ADA ID: RPRK220208174545

Access Compliance Report Public Rights-of-Way (Curb Ramps)

Main Street: DANA_DR	Cross Street: ISLAND_WAY	Location: S

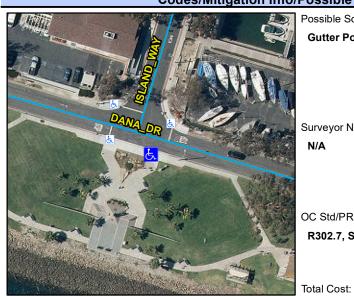
Overall Compliance: No

Possible Solutions:
Gutter Ponding Observed.

OC Std/PROW:
R302.7, STD 1115
